Access Compliance Report

Public Rights-of-Way

(Curb Ramps)

Intersection ID: 48454	Main Street: RED_RUST_LN	Cross Street: GOLF_LINKS_DR	Location: NW
ADA ID: 06503A7BB43B	Ramp Type: Perp	Initial Pass/Fail: Fail	Overall Compliance: No
Severity Score: 12.5			
Codes/Mitigation Info/Possible Solution		Field Measurements/Component Compliance

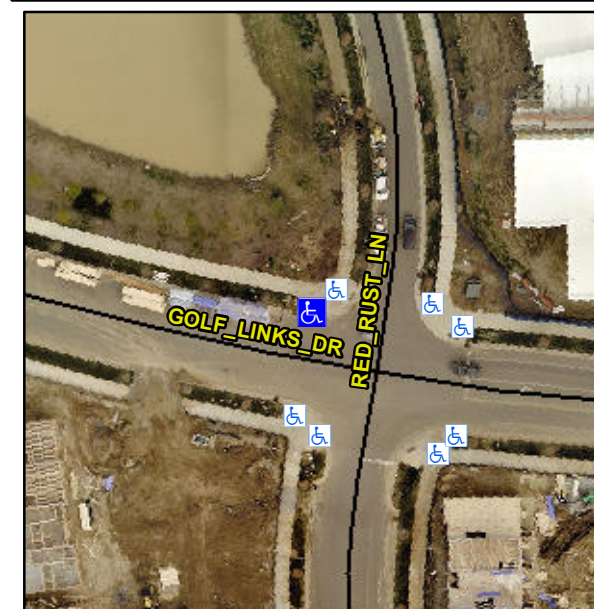
Not Found, R304.2.2

Compliance	Description	Data	Compliance	Description	Data
N/A	Ramp Length (in)	96.0	No	Ramp Slope (%)	8.9
Yes	Ramp Width (in)	60.0	Yes	Ramp XSlope (%)	1.0
N/A	Flare Type LT	N/A	N/A	Flare Type RT	N/A
N/A	Flare Slope LT (%)	N/A	N/A	Flare Slope RT (%)	N/A
N/A	Flare Traversable LT?	N/A	N/A	Flare Traversable RT?	N/A
N/A	Landing Length (in)	N/A	N/A	DWS Provided?	N/A
N/A	Landing Width (in)	N/A	N/A	DWS Contrast?	N/A
N/A	Landing Slope (%)	N/A	N/A	DWS Length (in)	N/A
N/A	Landing X Slope (%)	N/A	N/A	DWS Full Width?	N/A
N/A	Landing Curb? (Y/N)	N/A	N/A	DWS Offset (in)	N/A
N/A	Shared Landing?	N/A			
N/A	Gutter Ponding?	N/A	N/A	Gutter Slope (%)	N/A
N/A	Gutter Lip Ht (in)	N/A	N/A	Gutter X Slope (%)	N/A
N/A	Painted X Walk1?	No	N/A	Painted X Walk2?	N/A
	X Walk 1 Direction	To SW		X Walk 2 Direction	N/A
N/A	X Walk 1 Width (in)	N/A	N/A	X Walk 2 Width (in)	N/A
	X Walk 1 Slope (%)	3.5		X Walk 2 Slope (%)	N/A
	X Walk 1 X Slope (%)	0.8		X Walk 2 X Slope (%)	N/A

Remove & Replace Entire Ramp.
